INFORMATION BULLETIN NO. 46B

SUBJ: CLEVIS PIN RETROFIT PROGRAM FOR DRILLING CONTROLS – VALVES ONLY
– PHASE TWO

CLEVIS PIN RETROFIT PROGRAM – PHASE TWO

ILLUSTRATION NO. 2

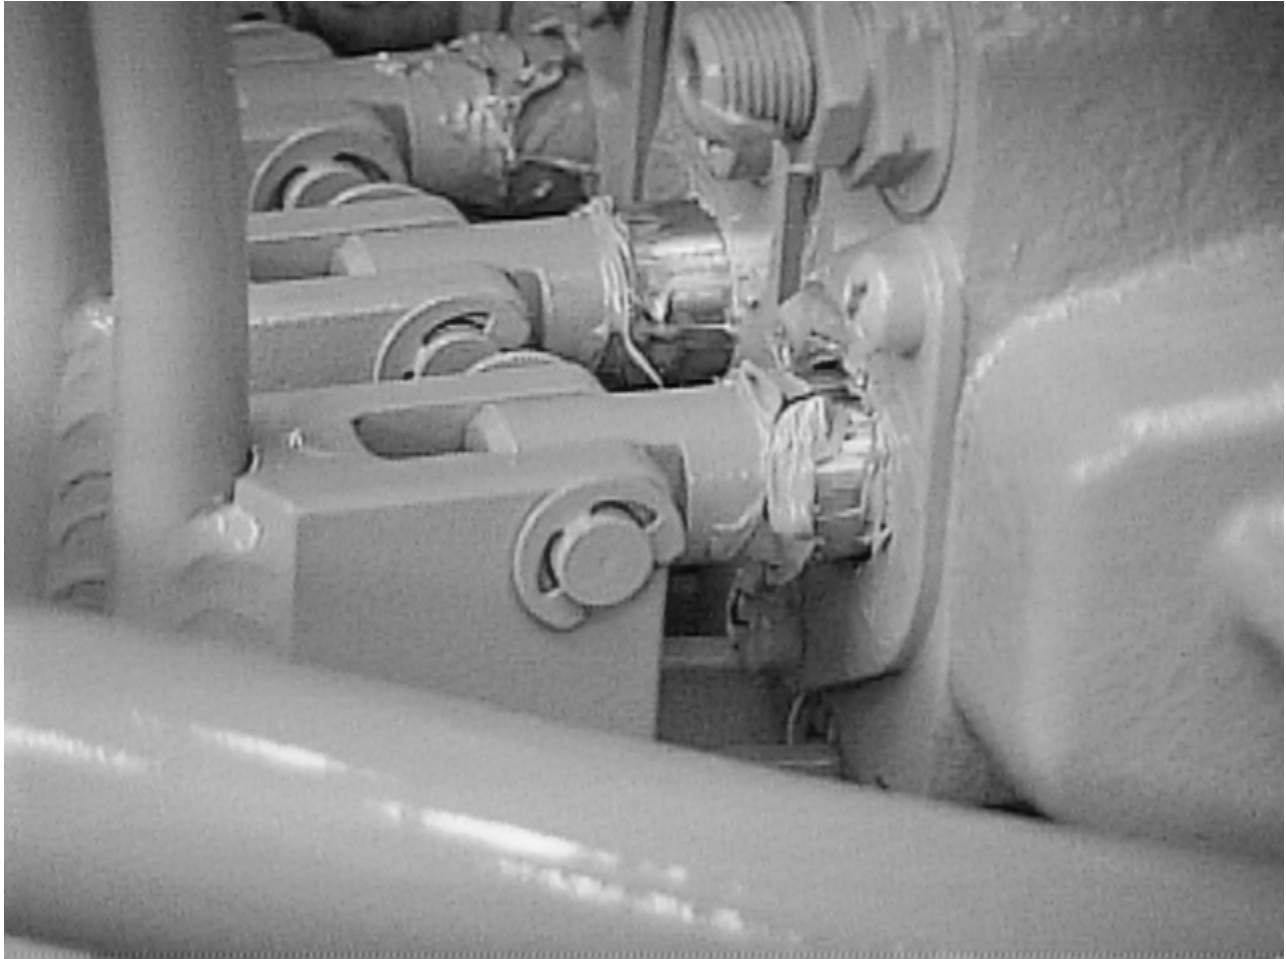
Recently, J. H. Fletcher & Co. discovered that the clevis pin arrangement may cause the rear valve bank handles to stick on cotter pins in the front valve bank of the drilling controls if specific mechanical conditions exist. The cotter key must extend vertically from the clevis pin and the handle must be bent to interfere with this cotter key. In order to reduce this potential risk from the use of this clevis pin arrangement, we are now undertaking a retrofit of the front pins on the forward valve bank (See Illustration No. 2).

If you own a DDO, DTO or RR11 **IMMEDIATELY** contact the J. H. Fletcher & Co. Service Department, COLLECT at 304/525-7811. Provide the serial number(s) for the affected unit(s) and request Retrofit Kit No. 159993. Each kit will be for use on the front valve bank arrangement, which will affect four (4) handles (feed, swing, extend, canopy post) and will require four clevis pins and eight "E" clips for each boom arm.

All future replacement clevis pins and cotter keys that are ordered under the existing part number 30378 will be shipped with this new design.
